SERVICE BULLETIN CHANGE NOTICE

S.B. No. A320-21-1025 REV. 2

TITLE : AIR CONDITIONING - AVIONICS VENTILATION - IMPROVE INSULATION OF
TEMPERATURE SENSOR AND ACCURACY OF SKIN TEMPERATURE READING.

REVISION TRANSMITTAL SHEET

At Shelf 88VU of electronics rack 80VU,
Replacement of Avionics Equipment Ventilation Computer (A.E.V.C.) 10HQ
Figure 1

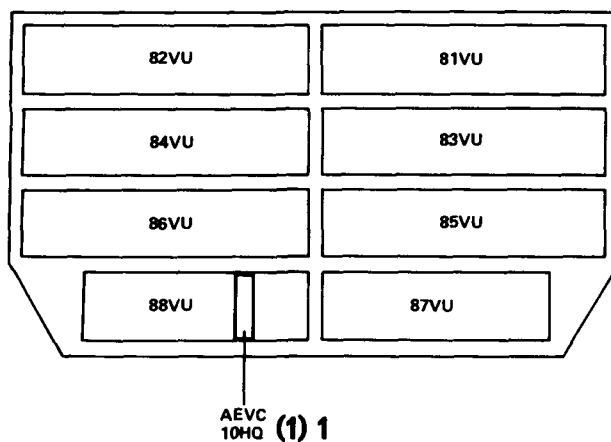
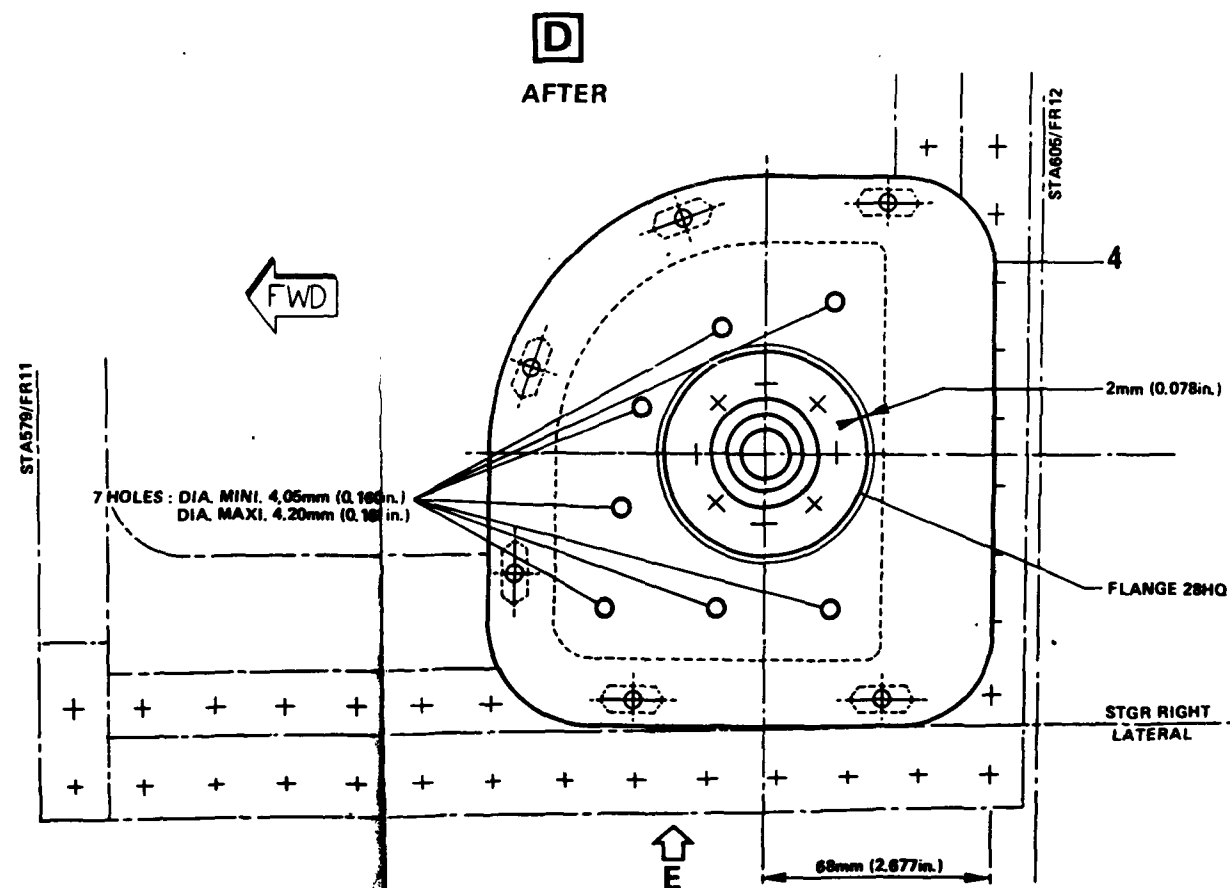
At the shelf 88VU of the electronics rack 80VU, replace the Avionics Equipment Ventilation Computer (A.E.V.C.) 10HQ (Ref. AMM 21-26-34, P. Block 401).

1 A.E.V.C. (10HQ)

1 modified A.E.V.C. (10HQ) 87292325V04 Item 1 (Ref. the instructions in CROUZET Service Bulletin No. 87292325-21-002).

Box and Insulation Installation
Figure 2

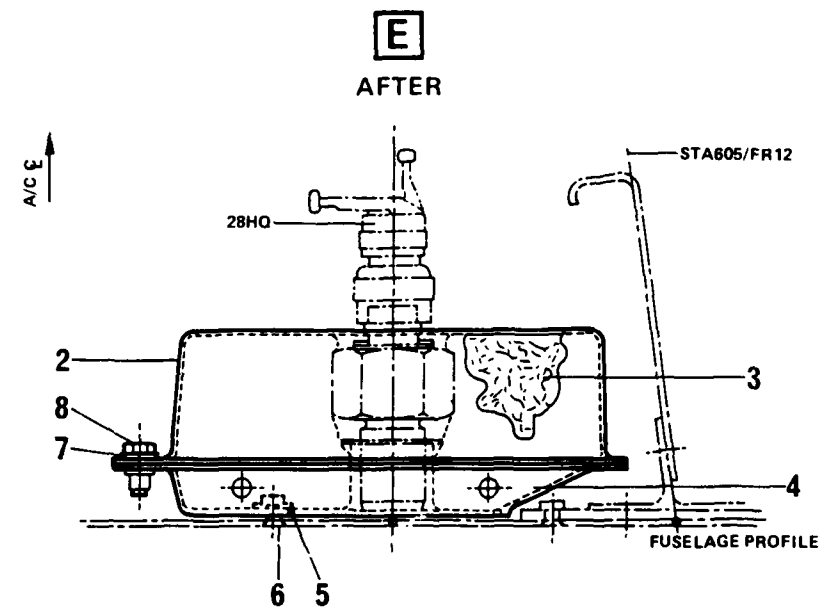
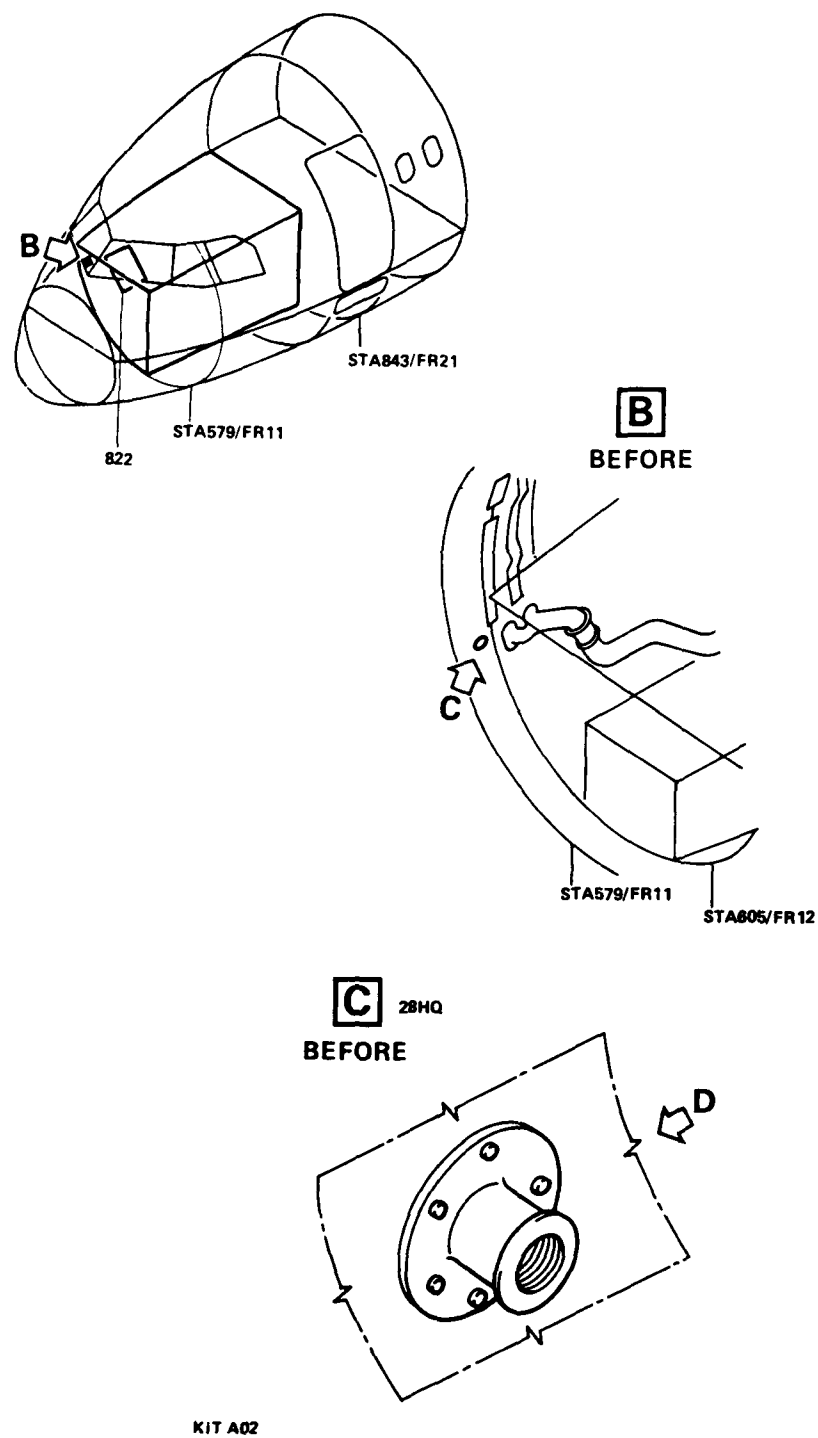
Install a box and a thermal insulation on the temperature sensor 28HQ.

(d) Position the half box D5391461900000 Item 4.

At level of half box/rivet line interference, locate and remove 3 rivets Item 6 (discard) from fuselage.

(e) On half box Item 4, mask and drill two 9 mm (0.354 in.) dia. holes ensuring the passage of rivet heads.

(i) Apply the Material No. 09-016 (Ref. CML) between the surfaces and attach Item 4 with :

7 rivets ASNA2051DEJ4018 Item 6

Read	: 7 rivets	ASNA2051DEJ4018	Item 6
Instead of	: 7 rivets	ASNA2051DCJ4018	Item 6
